South Australian Energy Transformation RIT-T: PADR Submission

Review of Riverlink RIT-T undertaken by ElectraNet

Figure 1 Representation of Riverlink

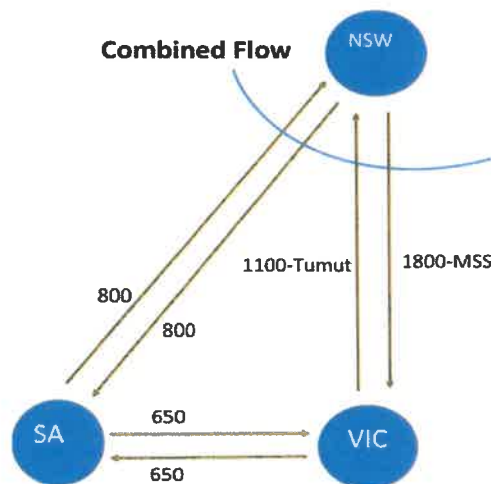
The NEM interconnector representation between NSW, Victoria and South Australia is shown in Figure 1. The numbers in the figure show the line limits.

The PADR and TTAR only present the interconnector line flow limits and total South Australian export and import limits due to all interconnectors connected to SA. To the knowledge of the author there are no combined limits to and from NSW (excluding QNI) presented in the PADR or the TNAR (or any of the other reports).

Figure 2 Representation of Riverlink

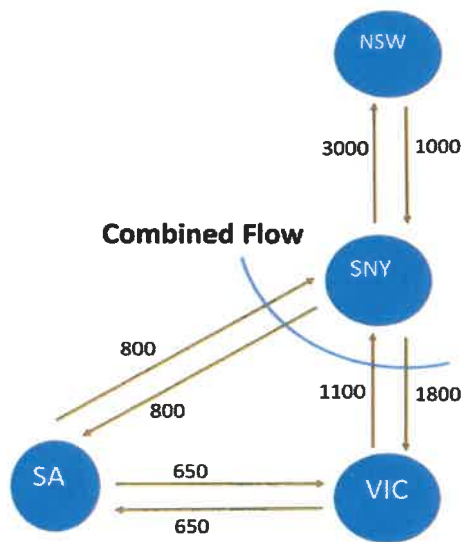
Figure 2 presents a simplified diagram of the physical constraints associated with interconnection limits between SA, Victoria and NSW⁴. This shows that by terminating at Wagga Wagga, flows from Riverlink are subject to the same transmission limits to NSW (reference node) as the existing Vic-NSW interconnector. Importantly also, by terminating

at Wagga Wagga, it is not stated how much additional firm capacity (under all conditions) is available to SA and Victoria from NSW (including Snowy Hydro).

In summary there is no quantification presented on the increase in import limit from NSW to the combined Victoria / SA region associated with Riverlink. This was recognised by ElectraNet at the “deep dive’ session.

The characterisation of Riverlink does not specify the limit on flows from NSW and Snowy generators to the combined SA and Victorian region.

The representation of the combined limits of the Vic-NSW and SA-NSW interconnectors are a most important issue and should be stated. The following are required:

- The net increase in limit to SA (across the cut set of Heywood and SA-NSW interconnector) under various conditions;
- The net increase in limit to NSW (across the cut set of Vic-NSW and SA-NSW interconnectors) under various conditions;
- How this was precisely represented in the modelling.

Figure 3 Heywood Interconnector Flow Duration Curve - SRMC and Realistic Bidding

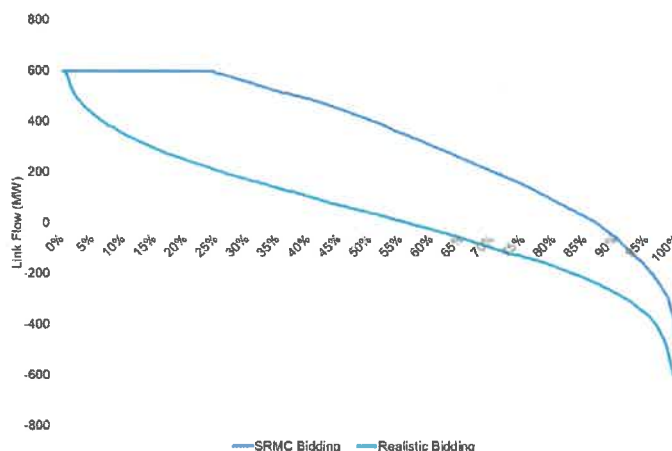
A comparison of the flow on the Heywood interconnector under SRMC and realistic bidding is shown in Figure 3 below. This shows the very significant impact SRMC bidding has on what has been observed⁹.

The comparison of Heywood flows under SRMC and realistic bidding shows much greater flows under SRMC bidding.

This reflect coal plant operating at substantially higher capacity factors

Figure 4 Change in Generation (incl. Storage) Installed MW due to Riverlink (1)

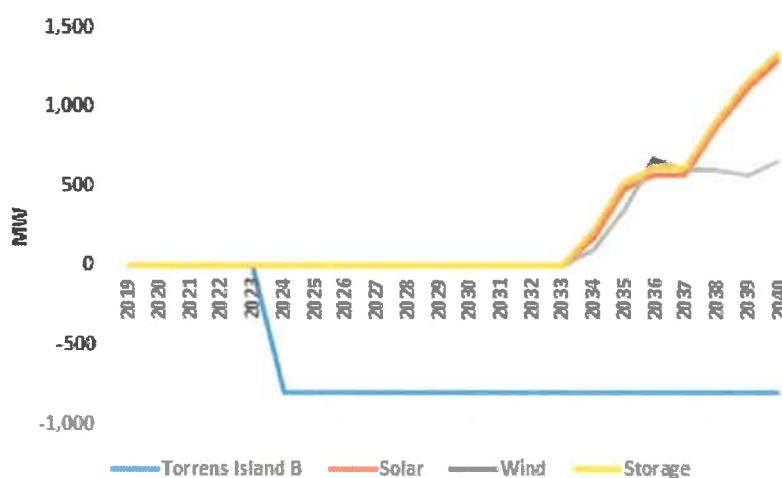
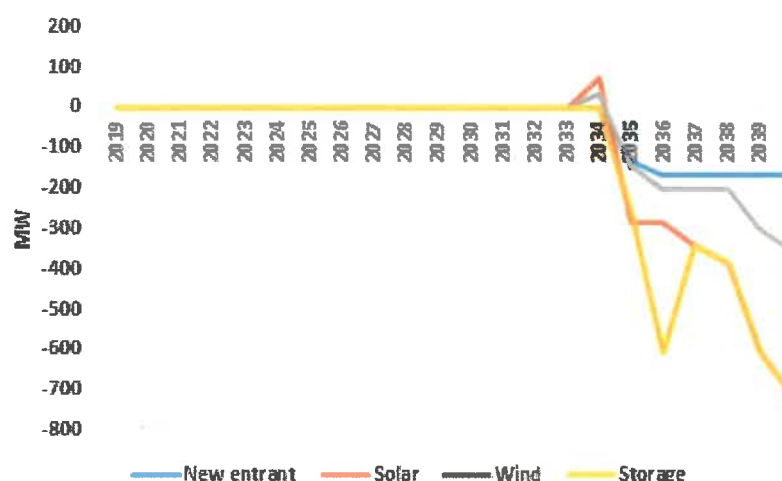
Observations from Figure 4 are as follows:

- Over the period 2024 to 2033, 800 MW of dispatchable capacity is removed from SA (Torrens Island B) without any other dispatchable generation developed in SA or Victoria. The interpretation from this is that Riverlink is assumed to be capable of providing 800 MW of firm capacity to SA;
- By 2040 Riverlink results in 3,285 MW of additional development in SA (1,314 MW solar, 657 wind, 1,314 MW storage) and 1,952 MW less development in NSW (166 MW new entrant, 714 MW solar, 357 wind, 714 MW storage). The hours of storage associate with the deferred storage is not specified. There are no changes in Victoria and Queensland;

Torrens Island closed in 2040. No other changes until 2033.

Solar development is matched with an equal capacity of storage. Hours associated with storage not provided.

Questions from these results not explained in the material provided by ElectraNet include:

- Is Riverlink assumed to provide 800 MW of firm capacity to SA? If so, what generation is being used to provide this firm capacity;
- The economics of an additional 1,971 MW of solar/wind generation in SA given the risk of demand reduction and the existing penetration of renewable generation in SA;
- The basis for 1,072 MW of solar/wind generation being more economic in SA than NSW is understood to be based on transmission deferral. The basis for this estimate has not be provided;
- Given the different regional sizes and penetrations of renewable generation, on what basis does Riverlink defer the same proportion of storage with renewables in NSW and SA (both States have 1 MW of storage linked to each MW of renewables).

Figure 5 Figure 7 from the RIT-T Modelling Report

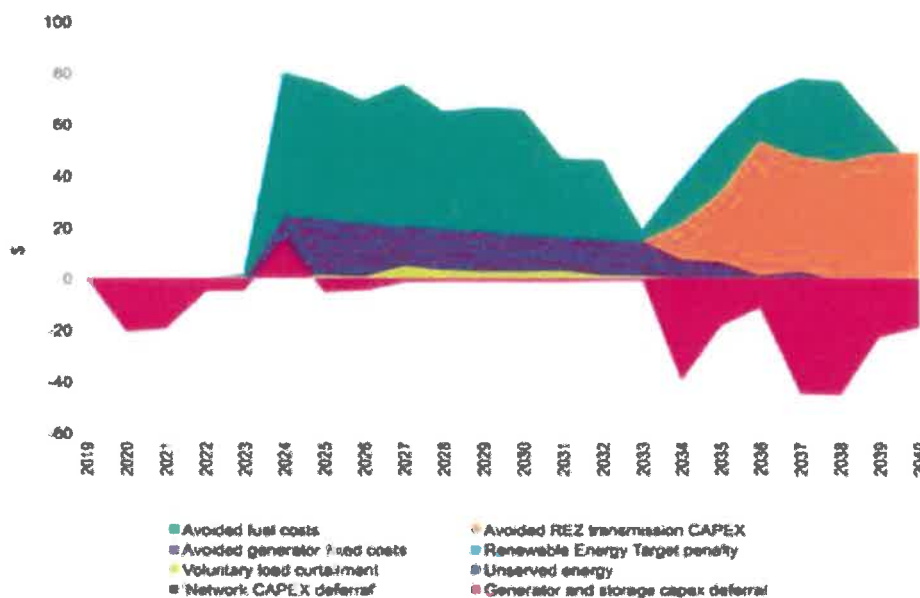
The PADR (Section 9.2 Gross market benefits – Modelling results) provides a high-level composition of the gross market benefits in Figure 7 of that report, and this is shown below in Figure 5.

From the above figure and the narrative, the following are noted:

An assessment of the unit costs of the market benefit categories (Central scenario) can be obtained through a comparison of the changes in generation (including storage) presented in Figure 4 and the market benefits presented in Figure 5. These unit costs are presented in the sections that follow.

Figure 6 ISP and ElectraNet Central Scenario

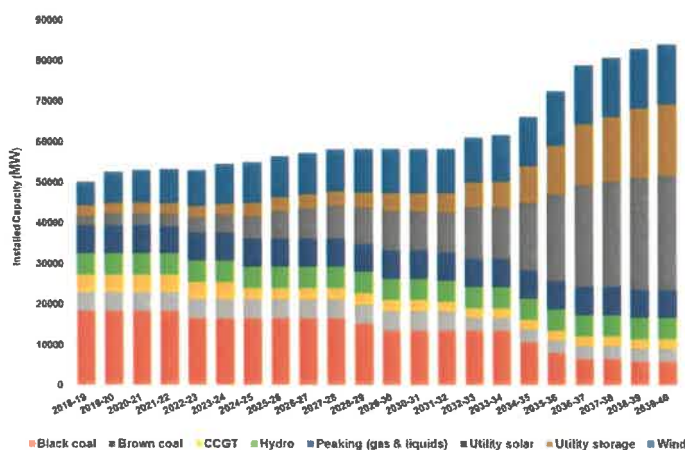
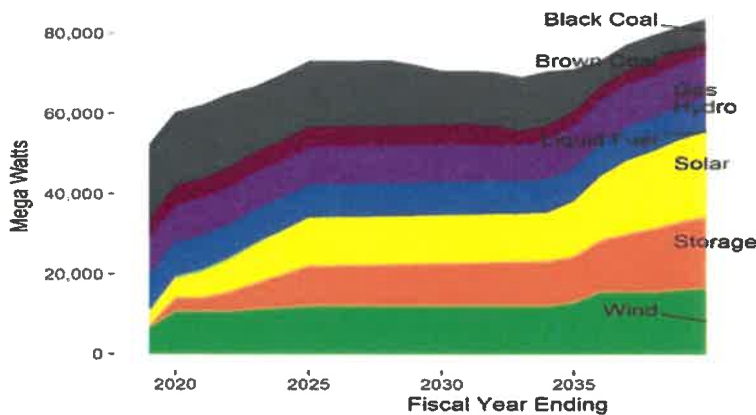
Figure 6 Error! Reference source not found. shows the graph of capacity development by type for the AEMO ISP Neutral scenario and for the by ElectraNet Central scenario¹² (noting the MMR did not disclose whether this included the project or not).

These differences are very difficult to explain given that “all material assumptions” have been stated as being the same.

These differences would have a material impact on the economics of a SA-NSW interconnector.
